Westinghouse  
Electric Corporation

NSD-NRC-96-4911  
DCP/NRC0681  
Docket No.: STN-52-003

SUBJECT: INFORMAL CORRESPONDENCE

# **Attachment 1 to Westinghouse Letter NSD-NRC-96-4911**

AP600 IRWST Drain to Flood Reactor Cavity

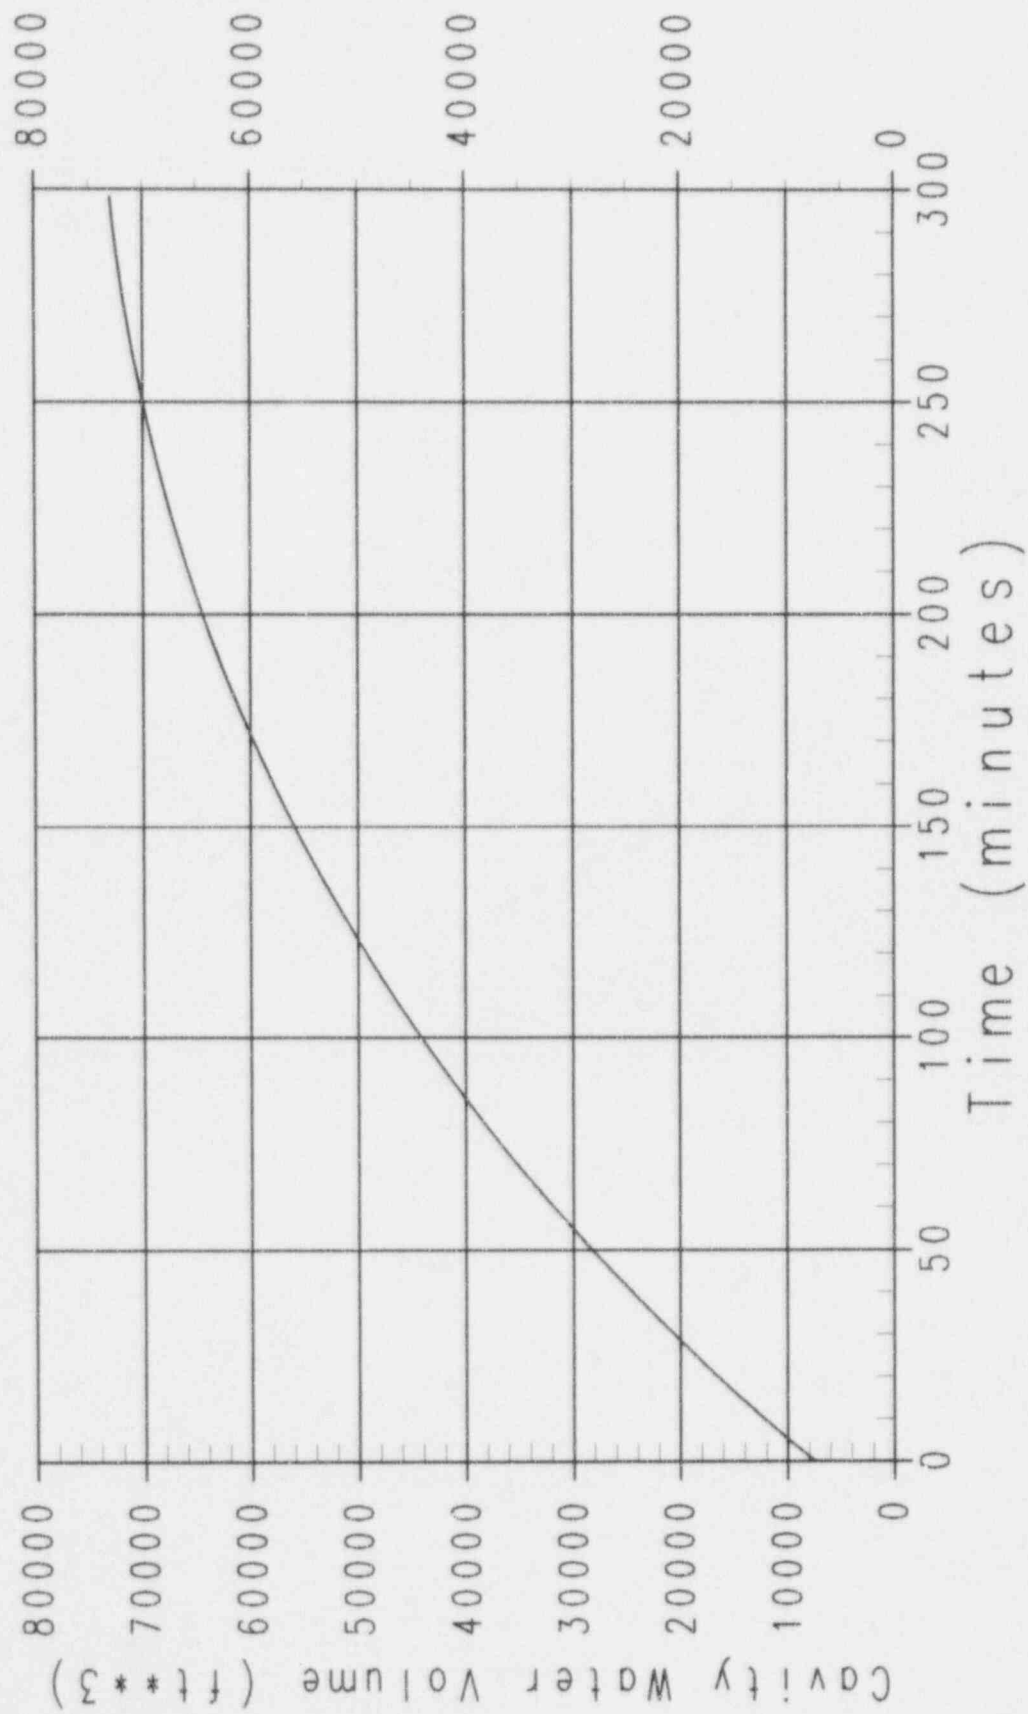
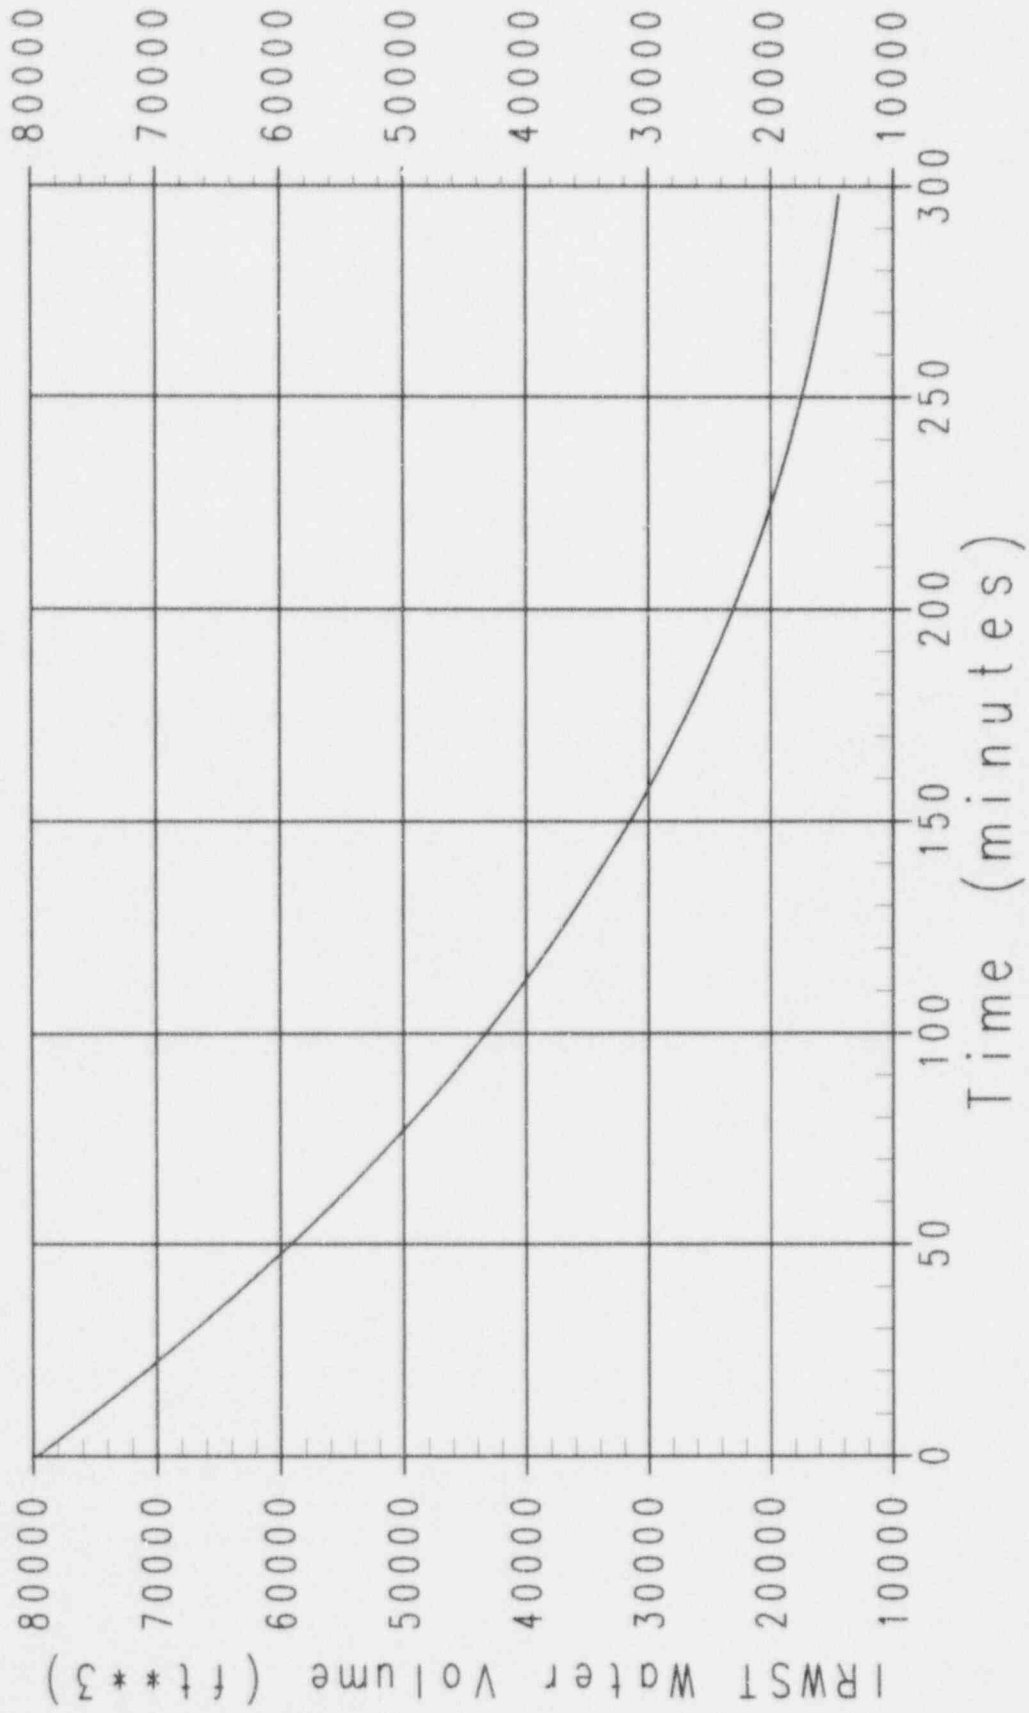
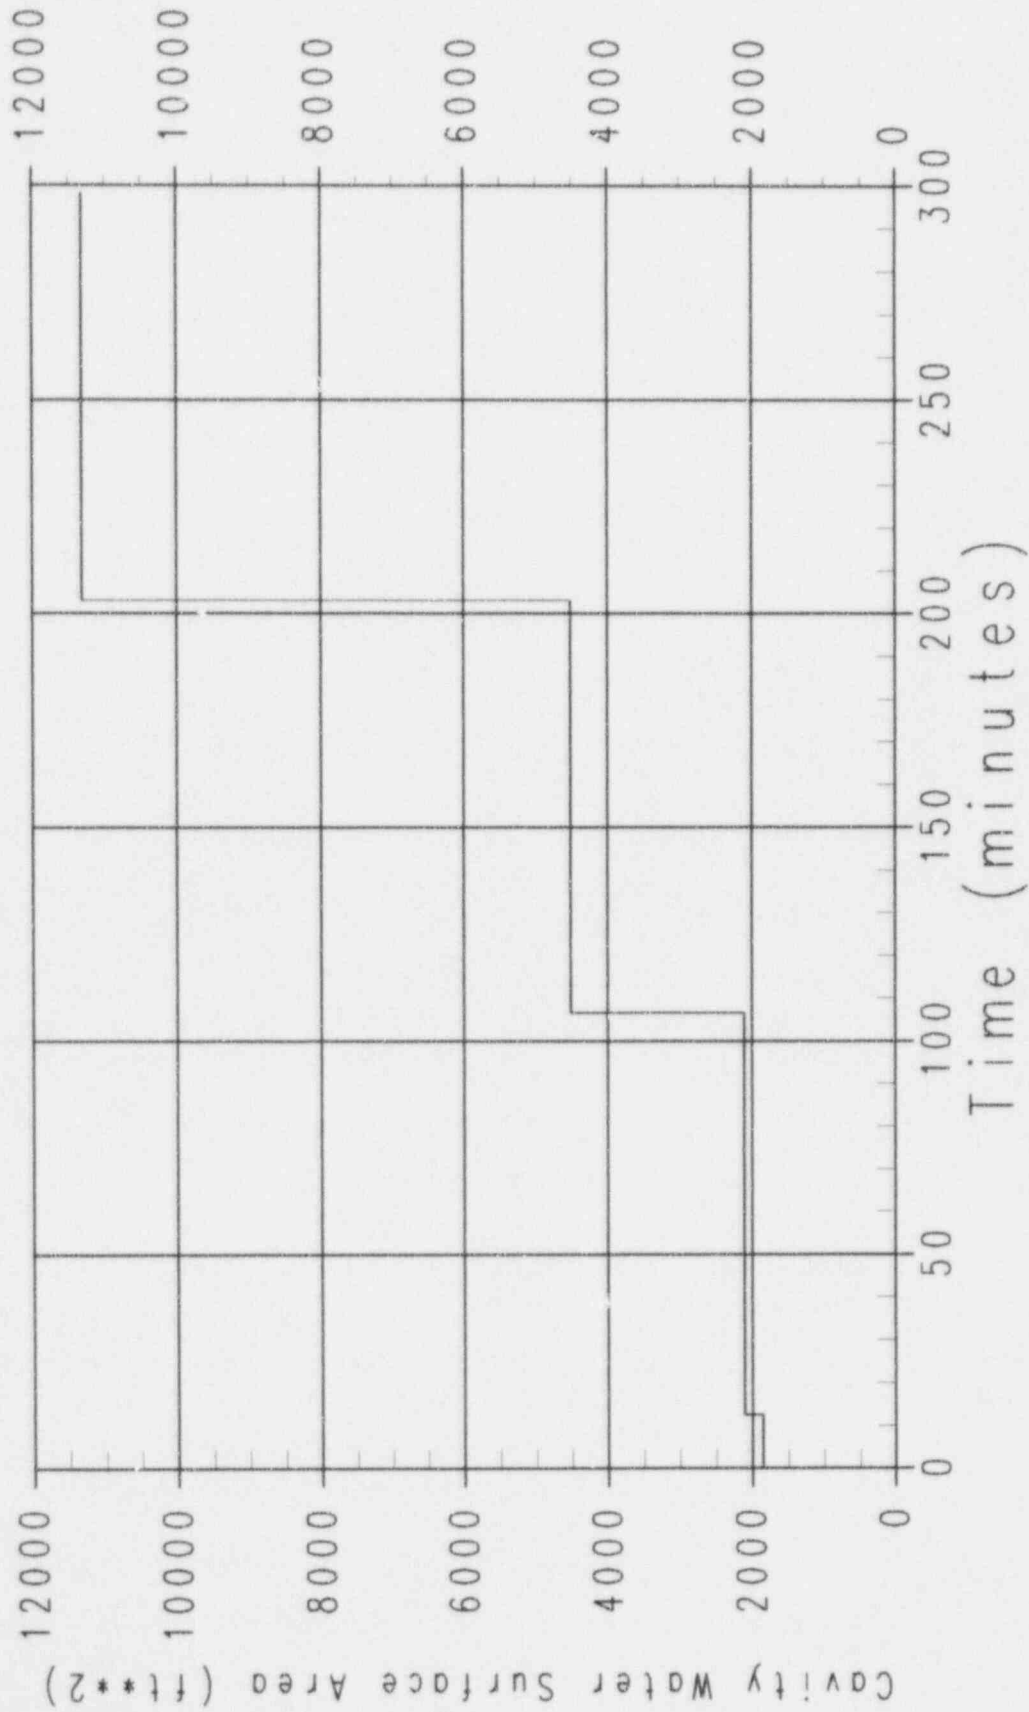
NRC REQUEST FOR ADDITIONAL INFORMATION

The distribution of this water in the containment is described in section 4 of WCAP-1470, WGOTHIC Application to AP600. Note that the final post accident containment water flood level is about the 108' 2" elevation. Since the IRWST bottom is at the 103' elevation, some of the IRWST will not drain. The IRWST has a internal surface area of 2760 ft<sup>2</sup>; this results in about 14260 ft<sup>3</sup> of water remaining in the IRWST.

In the event of a severe accident, the primary mixing mechanism is natural circulation driven by the hot reactor vessel containing the damaged fuel. Water and steam will flow up along the outside of the hot reactor vessel and into the loop compartments. The water carried into the loop compartments will flow through the corridor between the loop compartments past where the TSP baskets are located and down a vertical access tunnel to the reactor vessel compartment. This flow path promotes mixing of the TSP with the water inside the containment.
